UNDERGROUND STORAGE TANK (UST) CASE, REMEDIAL ACTION
COMPLETION CERTIFICATION: CASE RO0000056/CLAIM NO. 10630
CHEVRON #21-1283 EXPRESS AUTO CLINIC, 3810 BROADWAY, OAKLAND

UST CASE CLOSURE REVIEW SUMMARY REPORT
REVISED JUNE 2013 AS THE RESULT OF PUBLIC COMMENTS

USTCF Claim No.: 10630	Global ID: T0600101108
Site Name: Chevron #21-1283/Express Auto	Site Address: 3810 Broadway Oakland, CA 94611
Responsible Party #1: Gerald Friedkin	Address: 300 Grand Avenue Oakland, CA 94610
Responsible Party #2: Chevron EMC Attn: Ms. Kelly Esters	Address: 6101 Bollinger Canyon Rd., Room 5323, San Ramon, CA 94583
Responsible Party #3: Express Auto Clinic Attn: Mr. Joe Zadik	Address: 8255 San Leandro Street Oakland, CA 94621
USTCF Expenditures to Date: \$76,151	Number of Years Case Open: 21

FIGURE 3

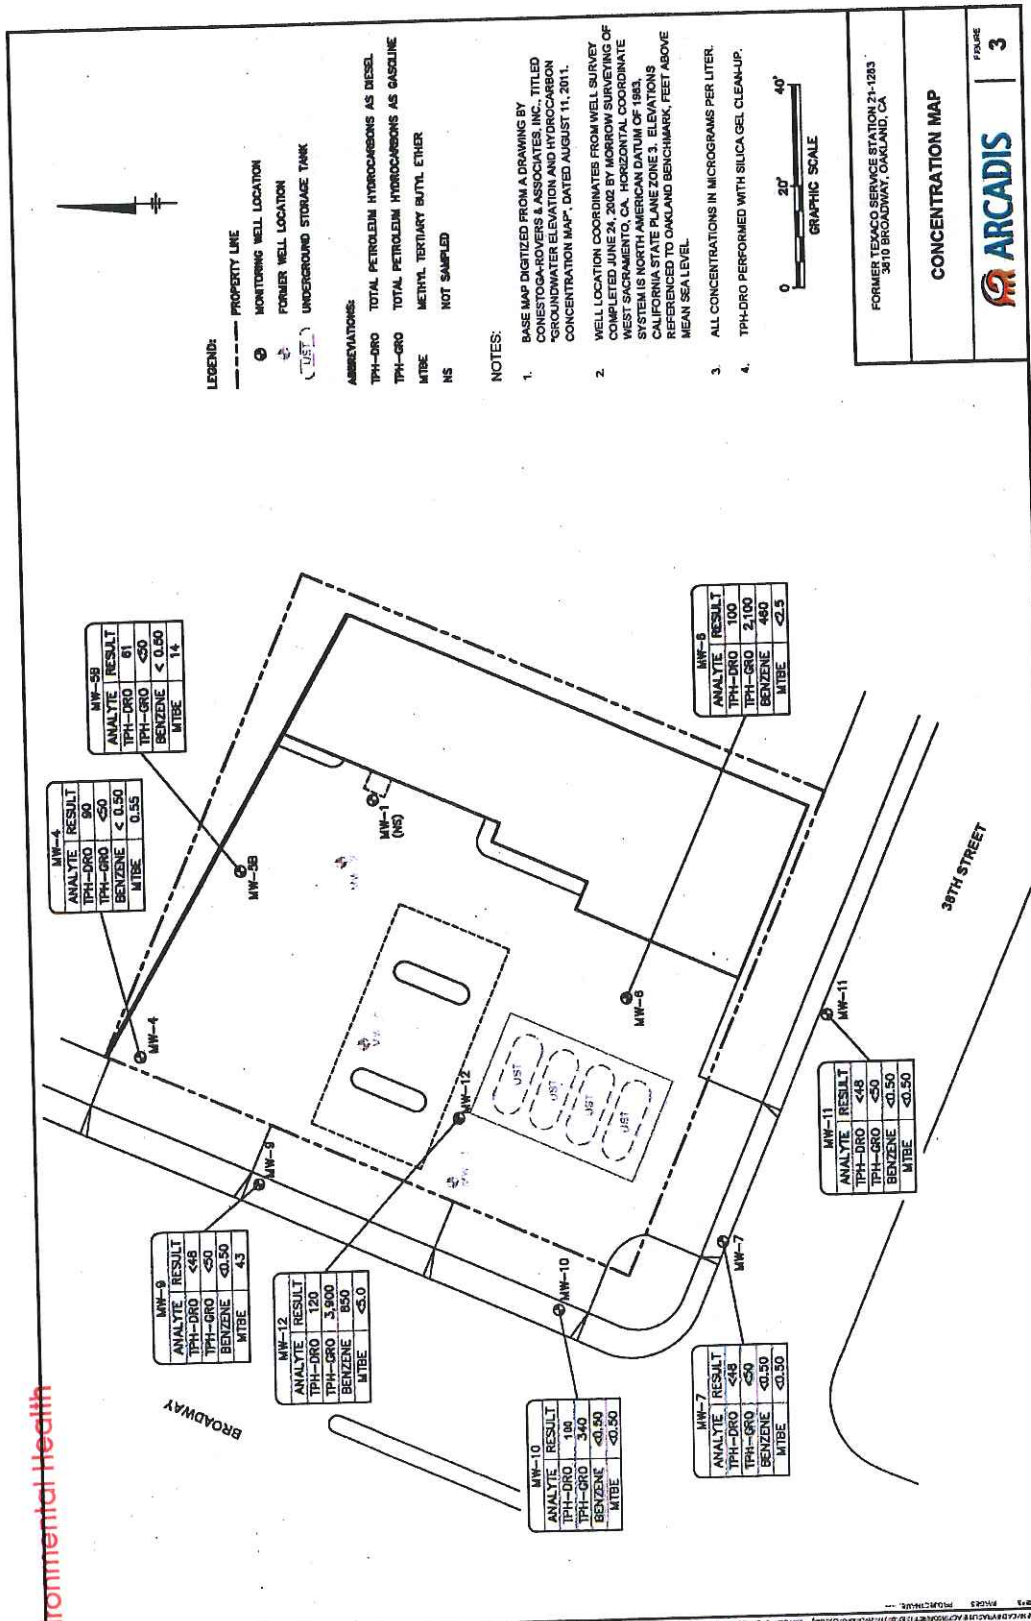
The County, as documented in the Closure Review located on the 09-42 Case Review page in GeoTracker (dated 4/15/2010) objects to UST case closure for this case because:

- Site characterization is not complete and contamination is not defined.
RESPONSE: Concentrations in soil and groundwater are defined to low to non-detect levels.
- Source control is feasible and needed to reduce offsite migration and reduce source mass.
RESPONSE: No free product has been documented in site wells since 2000. The

- Soil vapor risks are not identified.

- Designated beneficial uses of groundwater at the Site (municipal and domestic supply) need to be protected.

- Comment received during Public comment period: The County identified a creek 300 feet downgradient of the Site that was not visible using aerial photography.

RESPONSE: The Site is an active commercial petroleum fueling facility. Remaining maximum concentrations in soil are less than those in Policy Table 1 for both Commercial/Industrial and Residential land uses. Remaining petroleum hydrocarbon constituents do not pose a significant risk to human health.

RESPONSE: Water is provided to water users near the Site by East Bay Municipal Utilities District. The affected groundwater is not currently being used as a source of drinking water, and it is highly unlikely that the affected groundwater will be used as a source of drinking water in the foreseeable future.

RESPONSE: The creek is in an underground concrete culvert that extends at least 1,000 feet northeast and southwest of the hospital and parking structure. It is located on the northwest side of the KP property and was not seen during our evaluation. The RSR has been revised as the result of this new information. After further evaluation, instead of using Class 2 the Site meets the Policy criteria for Class 5.

The bottom of the culvert (creek) is located at 12 feet bgs (Oakland Public Works, 2013) and groundwater is at 19 feet bgs prior to the dewatering associated with the parking structure that maintains groundwater at a depth in excess of 30 feet bgs.. The minimum historical groundwater depth was 14 feet bgs. Groundwater dewatering beneath the parking structure has to be maintained or the lower levels of the structure will flood. Therefore the contaminated groundwater and the surface water body and the will never come into hydraulic contact.
